VILLA ORCHIDS

Details of Additions & Alterations

Villa No	186	Туре	Deluxe / Semi-Deluxe
Buyer Name	AP MUX	eshwala Ro	
Phone No.	96666360	70 Email	mukesh ap@gmail.

TERRACE FLOOR

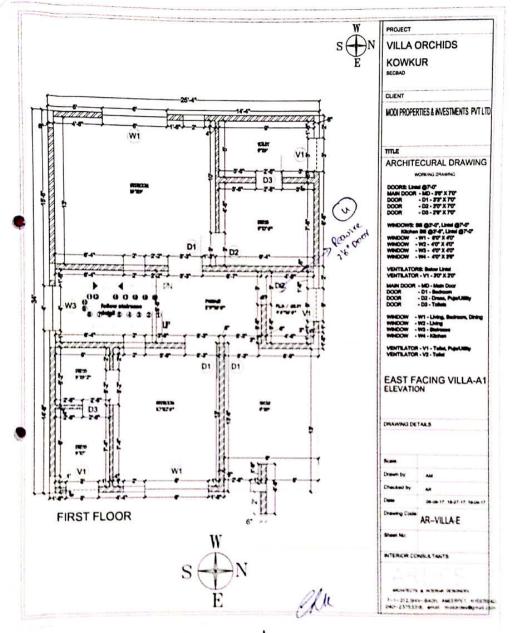
5110	пем	EMBOX
,	Distriction Board & Owings over	5~
2	Bellich board	Z
1	Well point/Brechat light	9
	5 amps plug point	•
	Cetting fam	J.
	Geyser point - 15A	C
,	Extend for	0
	15 amps plug point	Δ
	Talevision point	
10	Telephone point	2
**	Calling Ball	0
12	fiel Push	0
th.	Ceiting kgne	•
14	Video Phone	Dea.
**	AC Compressor	[ACC]
14	AC Blow	[ACB]
17.	Switch board with SA acciden
